Amulsar Gold Mine - Independent 3rd Party Assessment Impacts on Water Resources, Geology, Biodiversity and Air Quality

July 22, 2019

Figure 4.10.6: Small boulder with 50 plants of P.porphyrantha

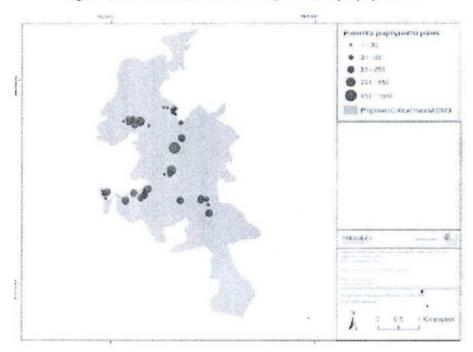
The distribution map of *Potentilla porphyrantha* (sampled points) is provided without description or mapping of the critical habitats for this species identified as "subalpine meadow with alpine elements" (in green in the below map) in which the species occurs on suitable rock substrate (see photo).

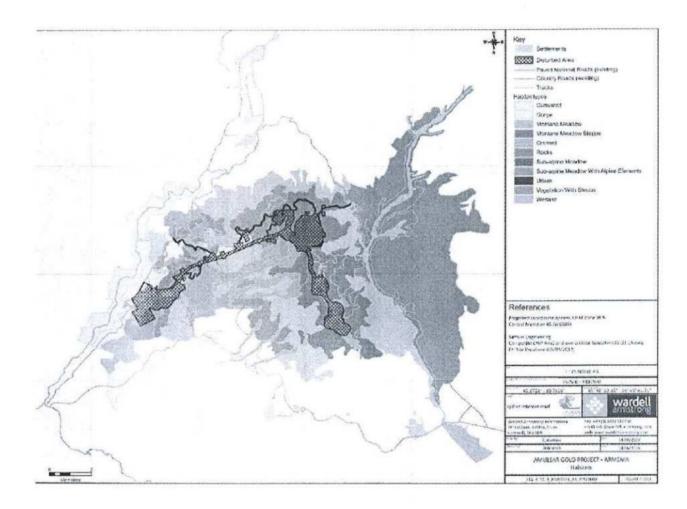
As per the map, the habitat will be heavily impacted by the project. The report states

"The physical footprint of the project on this species is estimated to be on 150.5 hectares (12.5% of the total area of critical habitat)".

This assumes that the species occupies the entire area of critical habitat (1200 hectares) when it occurs only on a subset of the area where suitable habitat occurs. Therefore, 12.5% is an underestimate of the area occupied by this species.
